SUBJECT: Entergy's Second Six-Month Status Report in Response to March 12, 2012
Commission Order Modifying Licenses with Regard to Reliable Spent Fuel
Pool Instrumentation (Order Number EA-12-051)
River Bend Station – Unit 1
Docket No. 50-458
License No. NPF-47

River Bend Station's (RBS) Second Six-Month Status Report for the Implementation of Order EA-12-051, Order to Modify Licenses with Regard to Reliable Spent Fuel Pool Instrumentation

9. Responses to the Interim Staff Evaluation Requests for Additional Information

Figure 1: SFP Plan View

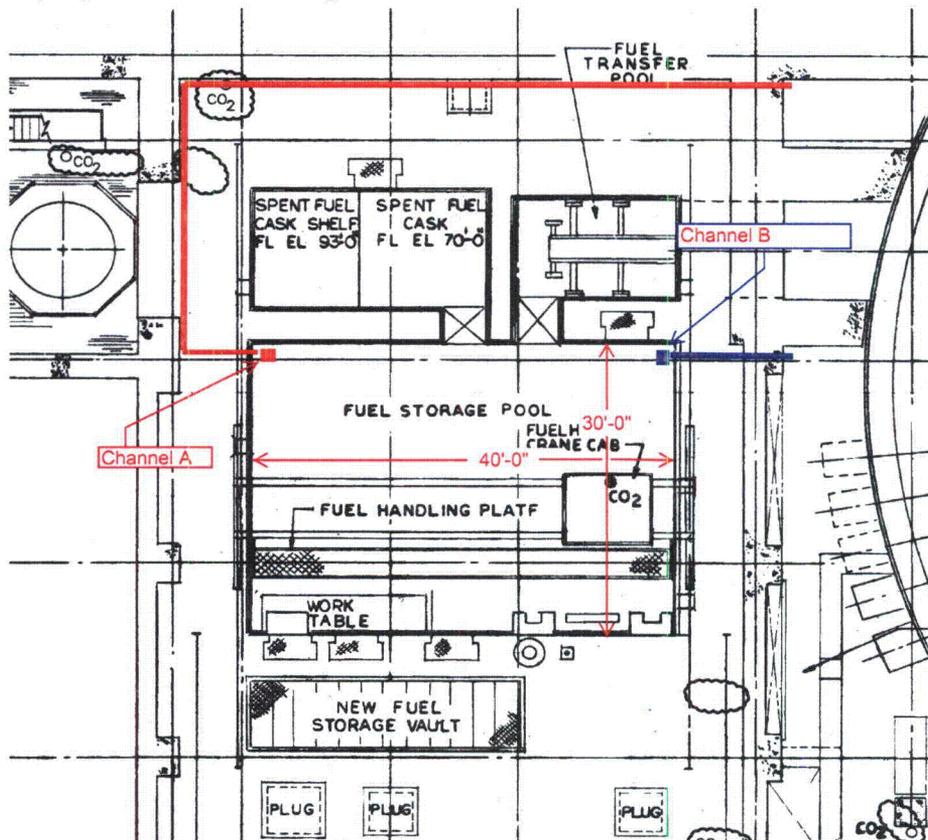
Please provide the updated sketch or marked-up plant drawing of the SFP level instrumentation arrangement. Include the plan view of the SFP area, depicting the SFP inside dimensions, the planned locations/placement of the primary and back-up SFP level sensor, and the proposed routing of the cables that will extend from these sensors toward the location of the read-out/display device.

Figure 1 shows the approximate locations of the SFPI probes, the inside dimensions of the SFP, and the proposed cable routing.
